Customer Existing Chair

Shev Chair Model # HC-77-PB Claremont with Padded Back

Modified Architectural Drawing to meet all changes discussed

New Model #: HC-77-P Claremont-P

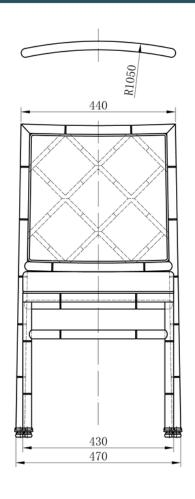
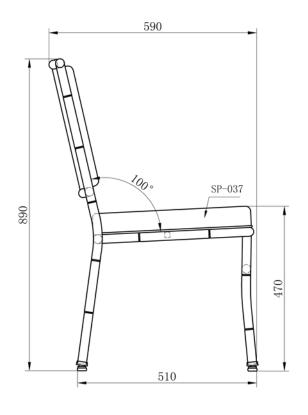
9. The legs and front cross bar should be constructed to match the customer's original chair, where the horizontal bars sit on top of the vertial leg, not like Shev's original chair that has the vertical leg go thru the horizontal bars and touches the bottom of the seat.
